**CHARLOTTE DOUGLAS INTERNATIONAL AIRPORT  
CHARLOTTE, NORTH CAROLINA**

**ADDENDUM NO. 2**

**NORTH END AROUND TAXIWAY (NEAT)  
OVERLOOK RELOCATION**

**CLT PROJECT NO. AVIA 23-50  
ADDENDUM DATE: MAY 25, 2023**

FILE NAME: SCALE: 1"=20'

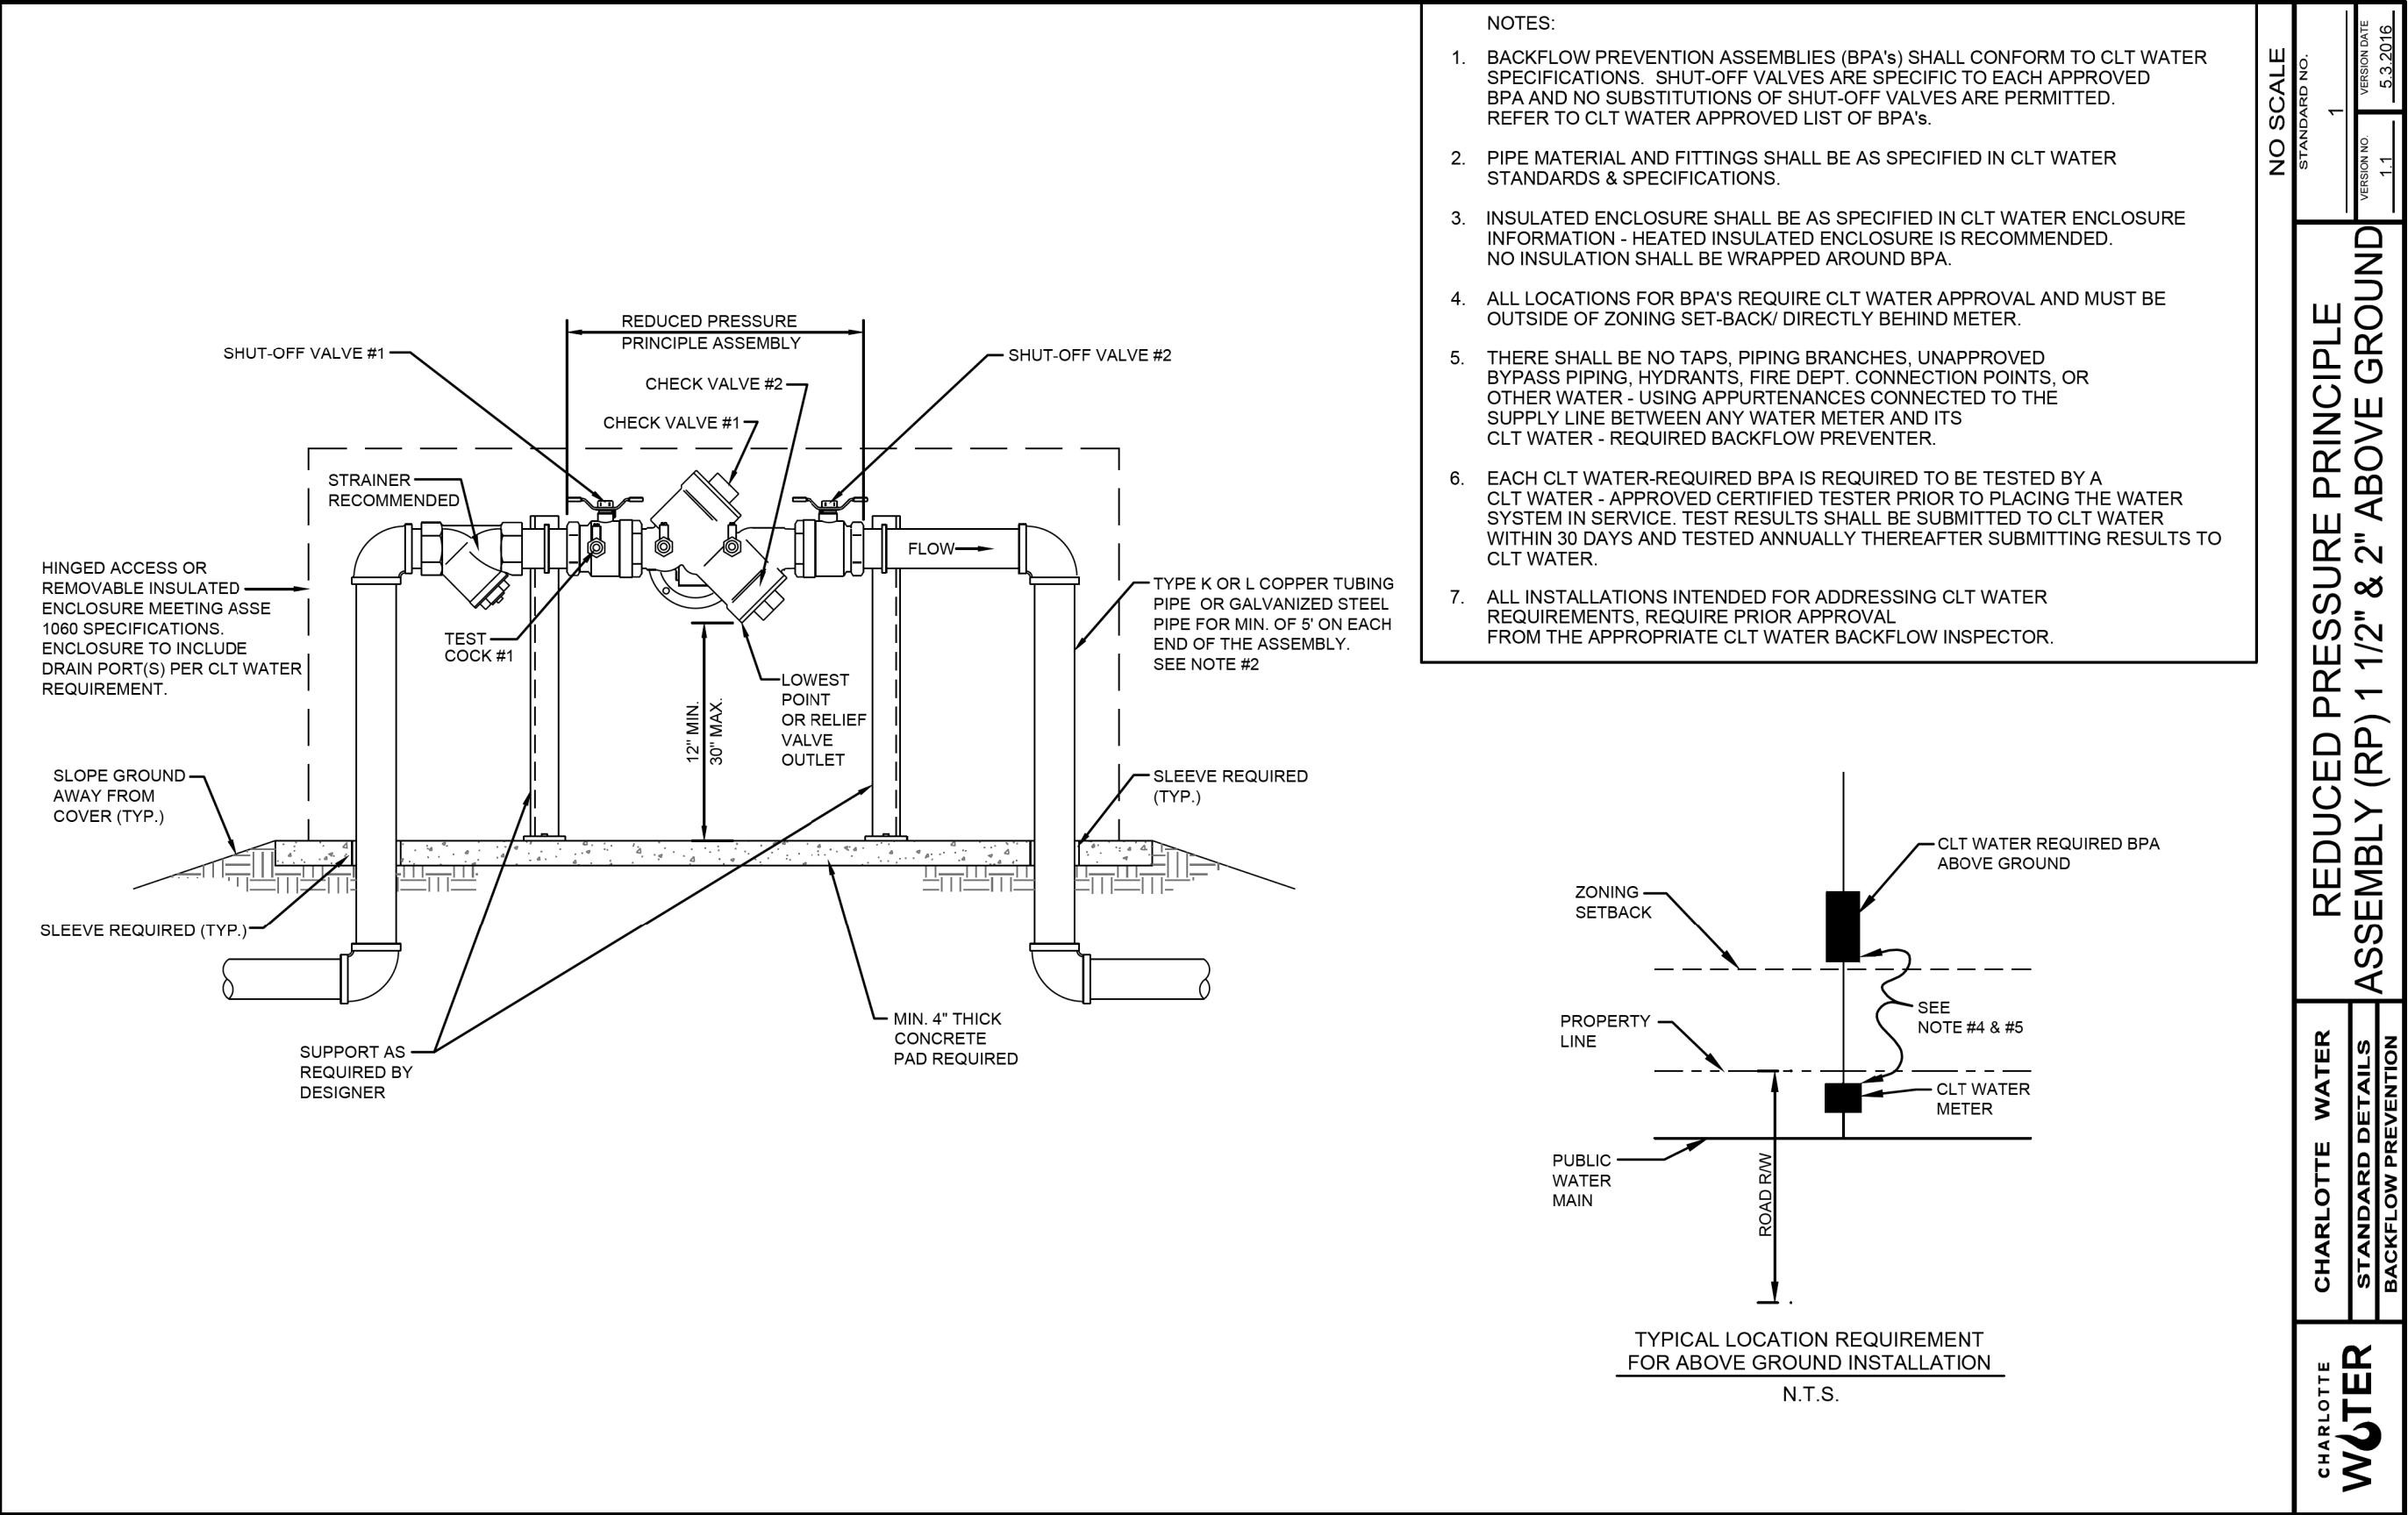
REVISIONS		DATE
1	ADDENDUM NO. 1 - REVISED AIRCRAFT DISPLAY AREA	05/15/2023
2	ADDENDUM NO. 2 - REVISED DUKE SUPPLIED PULLBOX DESIGN	05/25/2023
3		
4		
5

- NOTES:
- ALL LIGHT POLES/BOLLARDS ARE OFFSET 1' FROM EDGE OF NEAREST SIDEWALK UNLESS OTHERWISE NOTED.
  - BOLLARD LIGHTS SHALL BE TIED FROM ELECTRICAL PANEL TO PHOTOCELL FOR DUSK TO DAWN CONTROL. (SEE SHEET E-1 FOR DETAILS)
  - ALL ROADWAY/PEDESTRIAN LIGHT POLES SHALL HAVE 1-3" CONDUIT FROM LIGHT POLE TO NEAREST ELECTRICAL PULLBOX/JUNCTION BOX.
  - BOLLARD LIGHTS SHALL BE INSTALLED ON A CONCRETE BASE WITHIN THE SIDEWALK. (SEE SHEET 3A-9 FOR DETAIL)
  - CONTRACTOR SHALL INSTALL ALL DUKE SUPPLIED PULLBOXES. COORDINATE WITH YTULO EVANS 803-835-7945 TWO (2) WEEKS IN ADVANCE FOR DELIVERY OF PULLBOXES.
